_		rawings
<u> </u>	<mark>ase Sheet D</mark> Drawing	Modification Summary Effective: 2018-03-01
	Drawing	Modification Summary Effective: 2016-03-01
		Pole Assembly (ITS)-Series 1000
<u> </u>	M-ITS-1000	Elevation Views Pole Mounted ITS Element Assembly
<u>-</u> '	<u>VI-I I 3- 1000</u>	Added disconnect switch detail sheet.
<u> </u>		
<u> </u>		Minor editorial changes.
		Dynamia Massage Sign (ITS) Series 1400
<u> </u>	14 ITO 4400	Dynamic Message Sign (ITS)-Series 1100
_  '	M-ITS-1100	DMS Type 1 Electrical Plan
		Minor editorial changes.
	M-ITS-1101	DMS Type 1 Site Grounding Plan
		Minor editorial changes.
	M-ITS-1102	DMS Type 1 Typical Site Wiring Detail
		Minor editorial changes
	M-ITS-1103	DMS Type 2-Cantilever Electrical Plan
		Minor editorial changes.
		DMS Type 2-Butterfly Electrical Plan
<del>-</del>		Minor editorial changes
⊢,	M-ITS-1105	DMS Type 2 Site Grounding Plan
<u></u>	WI-113-1103	<u> </u>
<u> </u>		Clarified coarse wash gravel specifications.

M-ITS-1106

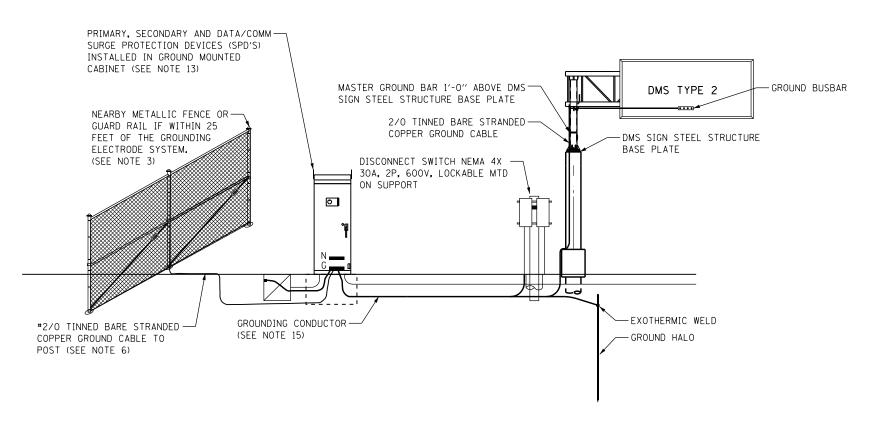
<u> </u>		Minor editorial changes.
<u></u> —'	M-ITS-1106	DMS Type 2 Site Wiring Details
		Minor editorial changes
	M-ITS-1107	DMS Cabinet Layout Detail
		Minor editorial changes.
ı	M-ITS-1108	DMS Cabinet Wiring Diagram
		Minor editorial changes.
		Cabinet Wiring (ITS)-Series 1200
м	I-ITS-1200 to	
	M-ITS-1255	Cabinet Wiring Diagrams
<del> </del>	11-110-1200	Revised DIN3 IP relay to DIN4.
М	I-ITS-1200 to	Interised blind in relay to blind.
	M ITC 4207	
		Cabinet Wiring Diagrams
	W-ITS-1210,	
<u> </u>	M-ITS-1255	
<u> </u>	170 1000 1	Added single mode fiber patch panel.
